**SUBJECT: STOP SALE / DEMONSTRATION / DELIVERY HOLD
Safety Recall 13S12**

All 2013 Model Year Escape Vehicles Equipped with a 1.6L Engine
Risk of Localized Overheating of the Engine Cylinder Head that May Lead to Oil Leak
Fires

REF: Advance Notice – Safety Recall 13S12
Dated November 25, 2013

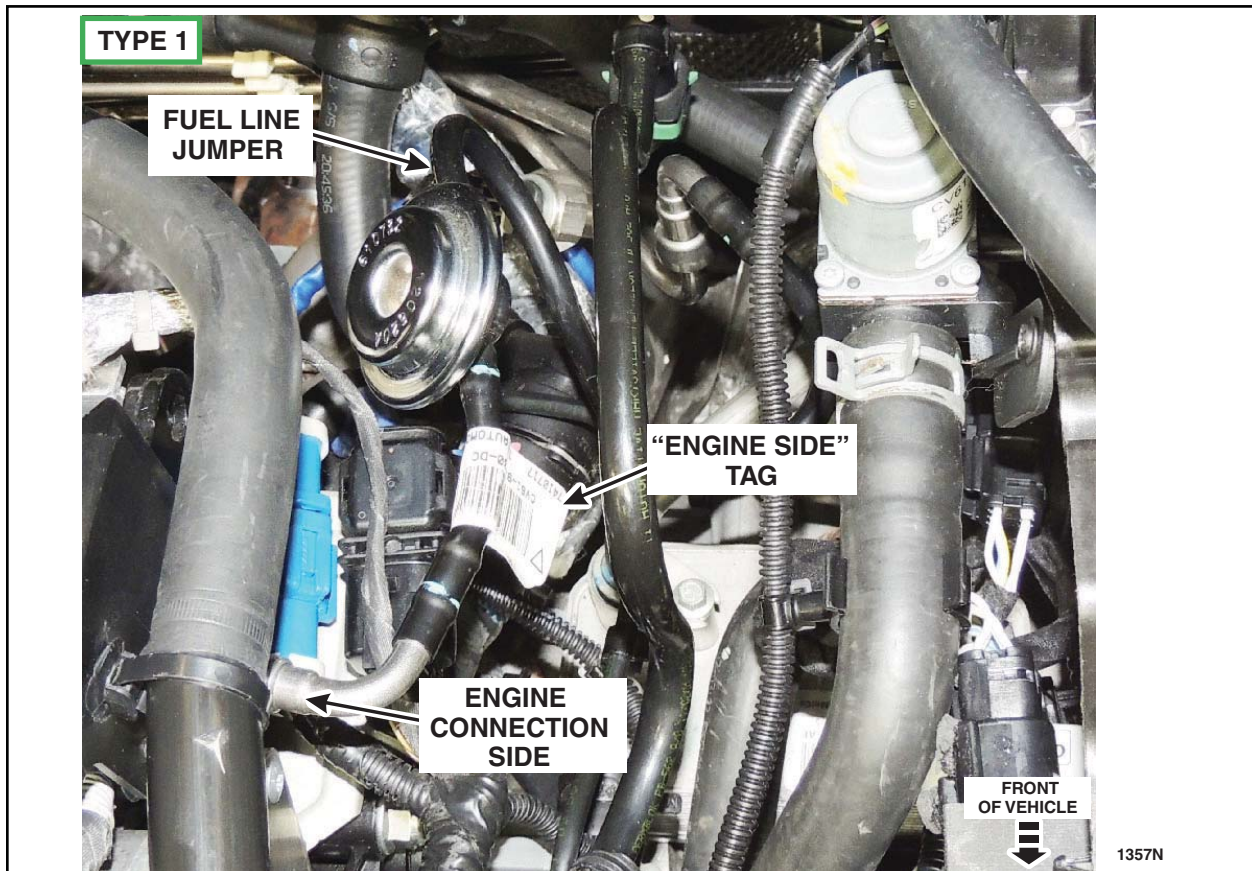
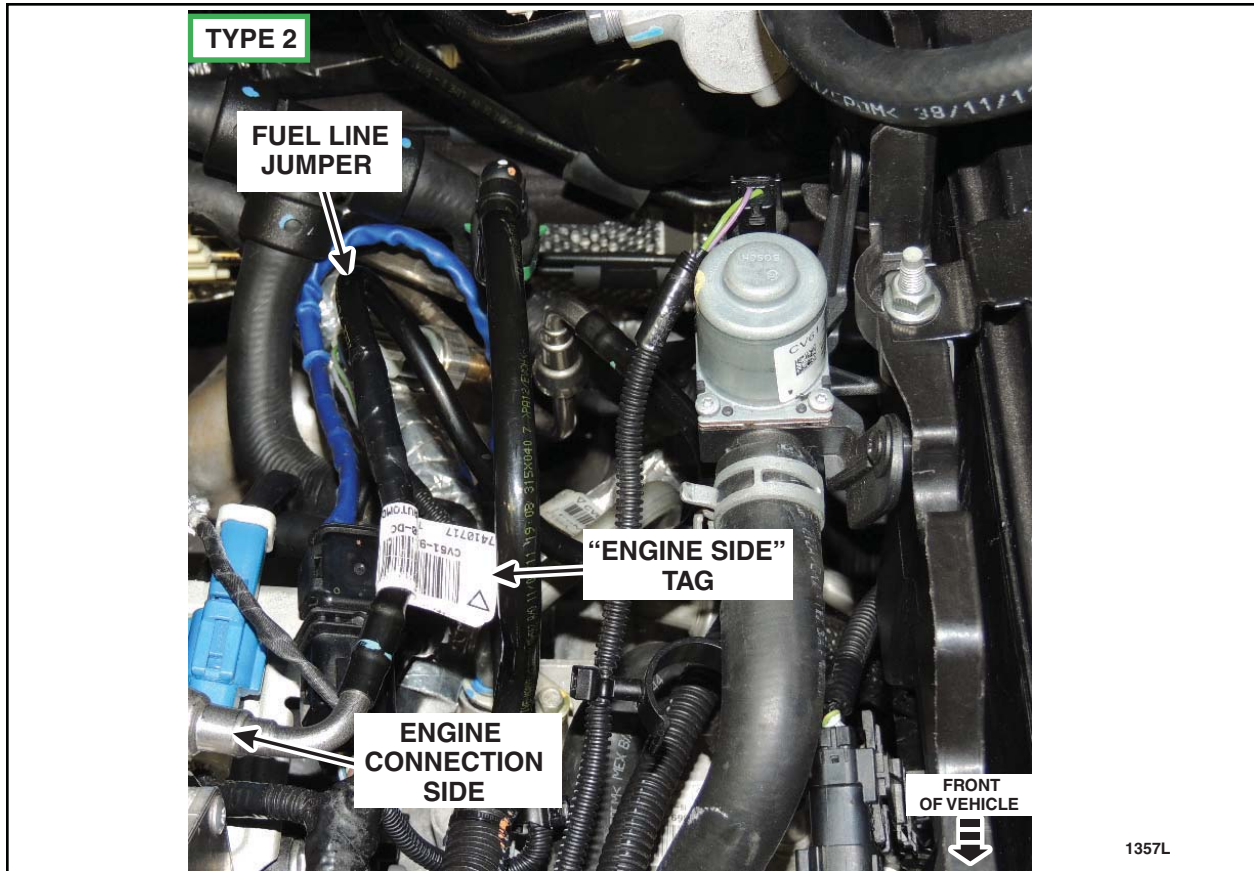
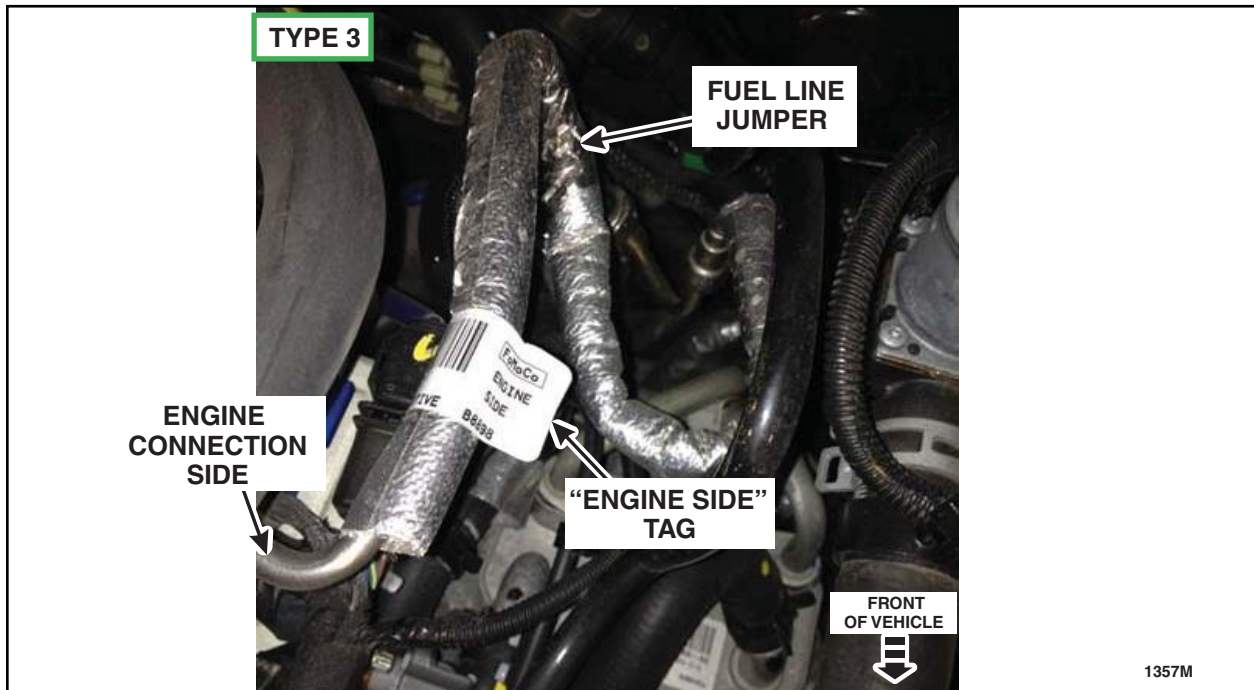
5. Inspect the fuel line jumper orientation. See Figure 2, 3, and 4.

For all three of these line types, the correct installation is with the white "ENGINE SIDE" tag on the line closest to the engine connection side. See Figure 2, 3, and 4, for examples of correct installations.

- If the fuel line jumper **is** installed as shown, with the "ENGINE SIDE" tag located closest to the engine (front of vehicle), no further action is required. Reassemble the vehicle by reversing the removal procedure.
- If the fuel line jumper **is not** installed as shown, with the white "ENGINE SIDE" tag located closest to the engine (front of vehicle), proceed to "Fuel Line Jumper Replacement".

FIGURE 8

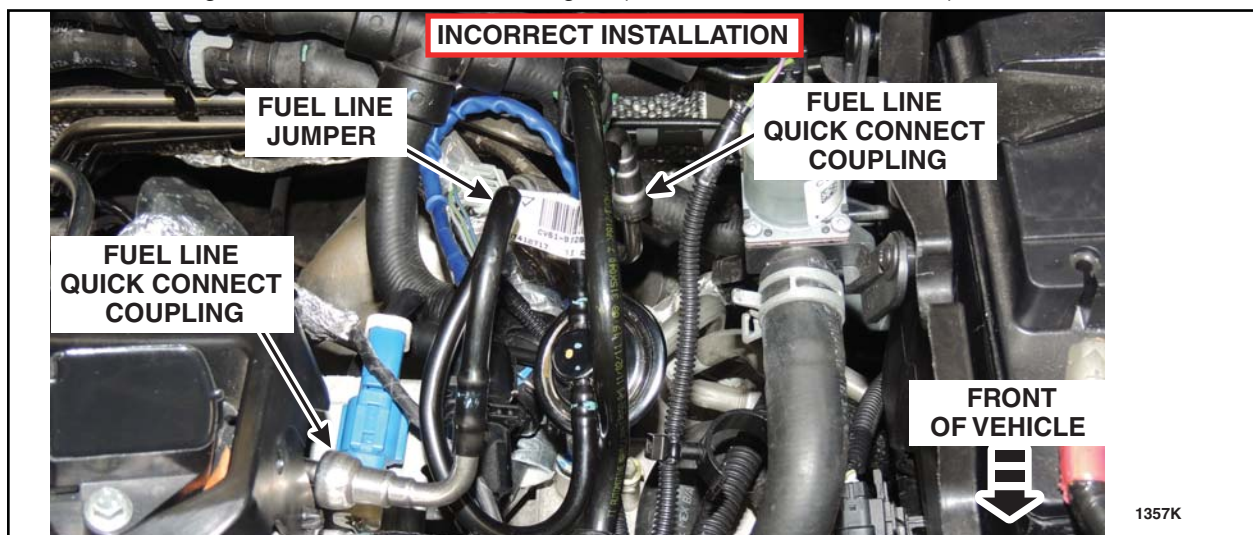
8. Remove and discard the fuel line jumper. See Figure 8.

NOTE: The fuel line jumper shown is installed in the **incorrect orientation** with the "ENGINE SIDE" tag **not** located closest to the engine (further from front of vehicle).

FIGURE 9

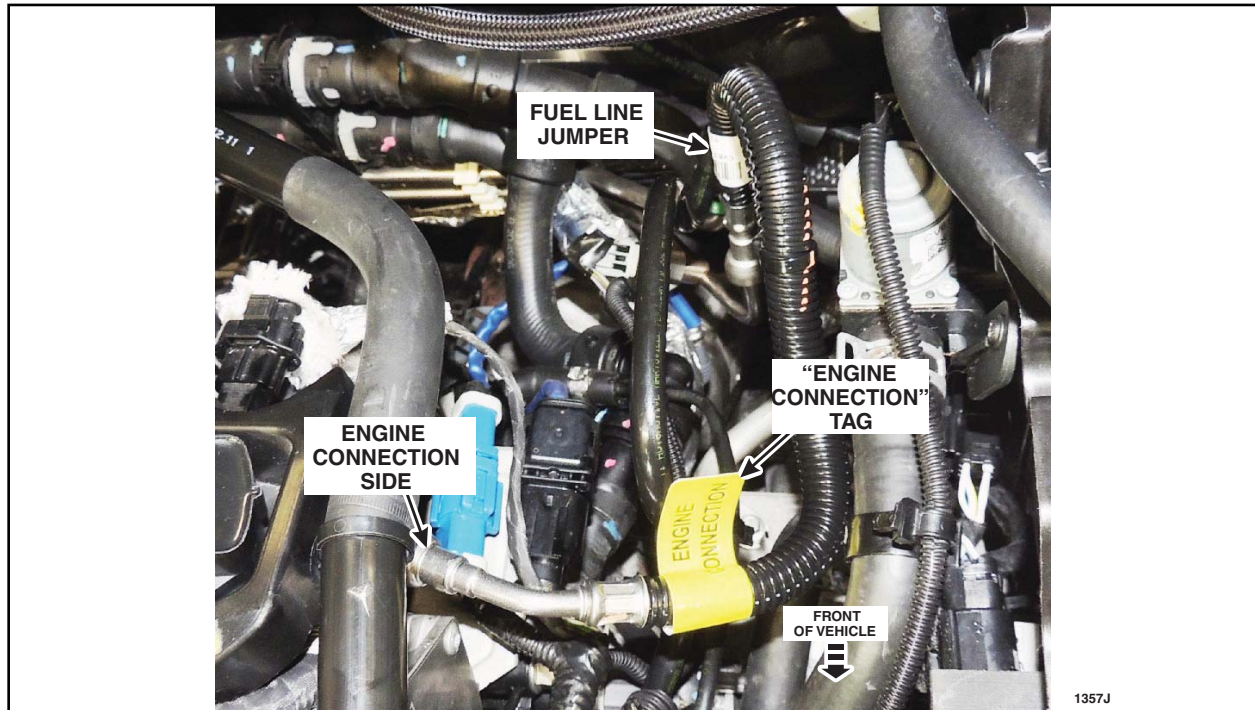
NOTE: Once the fuel line jumper is installed, the yellow "ENGINE CONNECTION" tag should be positioned closest to the engine (front of vehicle). See Figure 9.

- Be sure that the yellow "ENGINE CONNECTION" tag is positioned closest to the engine (front of vehicle) before attachment. See Figure 9.
- Connect the engine side of the fuel line jumper first.
- Push the fuel line jumper connectors onto the lines. Listen for a click, then pull on the connectors to verify proper attachment.
- After installation is complete, carry out a Key ON Engine OFF (KOEO) visual inspection for fuel leaks.
